# ADA Curb Ramp New Construction Inspection Form (Parallel)

Nw 314th ave.

24952.54

Nw. Cottage st

PARALLEL RAMP (PL)

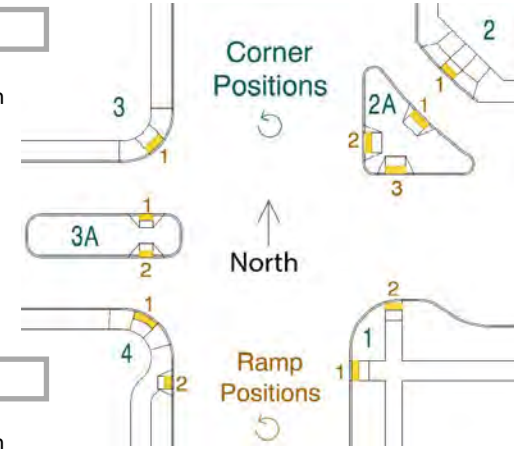
Running Slope 1	9.4	$\leq 2.0\%$	<input type="checkbox"/>	$> 2.0\%$	<input checked="" type="checkbox"/>
Cross Slope 1	1.4	$\leq 2.0\%$	<input checked="" type="checkbox"/>	$> 2.0\%$	<input type="checkbox"/>
Detectable Warning	N	Y	<input type="checkbox"/>	N	<input checked="" type="checkbox"/>
Lip Height	0.5	$\leq 1/4"$	<input type="checkbox"/>	$> 1/4"$	<input checked="" type="checkbox"/>
Gutter Flow Slope	0.7	$\leq *$	<input checked="" type="checkbox"/>	$> *$	<input type="checkbox"/>
Curb Running Slope (avg)	<input type="checkbox"/> 2.34	$\leq 8.3\%$	<input checked="" type="checkbox"/>	$> 8.3\%$	<input type="checkbox"/>
Counter Slope (+/-)*2	10.5	$\leq  5.0\% $	<input checked="" type="checkbox"/>	$>  5.0\% $	<input type="checkbox"/>
Det. warning full width of ramp	N	Y	<input type="checkbox"/>	N	<input checked="" type="checkbox"/>

Running Slope 2	12.6	$\leq 8.3\%$	<input type="checkbox"/>	$> 8.3\%$	<input checked="" type="checkbox"/>
Length 2					
Cross Slope 2		$\leq 2.0\%$	<input type="checkbox"/>	$> 2.0\%$	<input type="checkbox"/>

Running Slope 3	13.4	$\leq 8.3\%$	<input type="checkbox"/>	$> 8.3\%$	<input checked="" type="checkbox"/>
Length 3					
Cross Slope 3		$\leq 2.0\%$	<input type="checkbox"/>	$> 2.0\%$	<input type="checkbox"/>

No dome, no RR2, no RR3
